# PRODUCT CHANGE NOTIFICATION

### **Bourns® Model SRN4018 Series Semi-shielded Power Inductors** *Design Changes and Additional Sources for Inductor Core and Reel*

IC23029

Figure 1

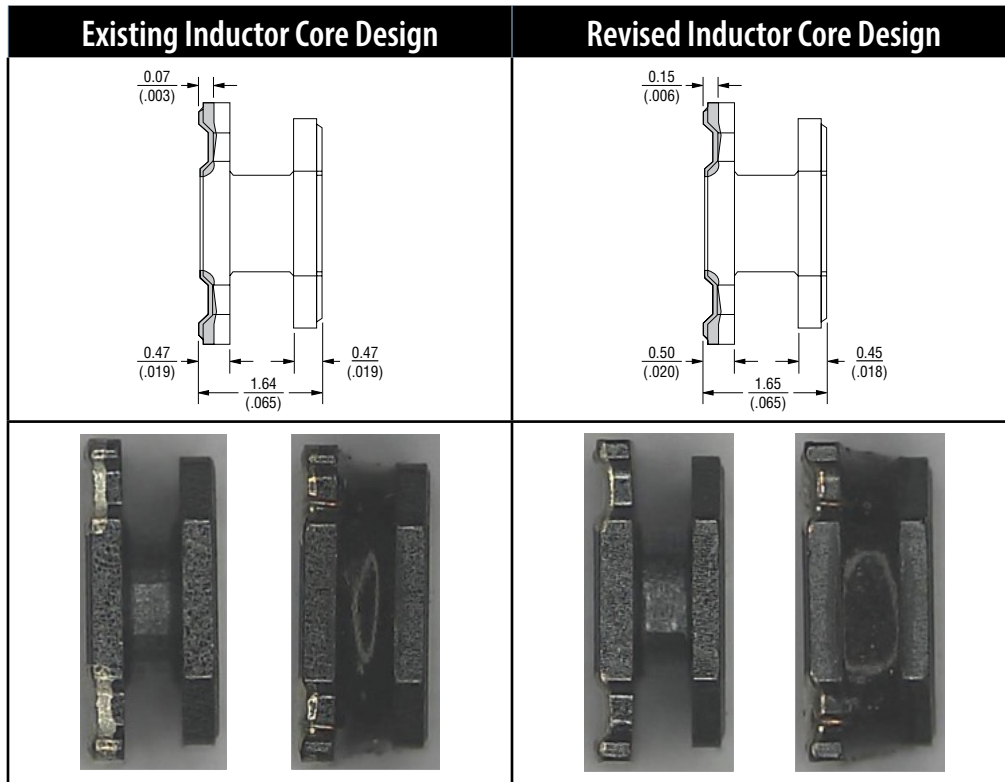
Riverside, California – July 18, 2023 – In the spirit of continuous improvement, effective November 15, 2023, Bourns will change the inductor core and reel design for the [Model SRN4018 Semi-shielded Power Inductors](#). The modified inductor core will have a deeper wire groove to strengthen the coplanarity of the solder terminal. The structure of the reel has also been changed from a modular type to an integrated type to provide a more solid structure.
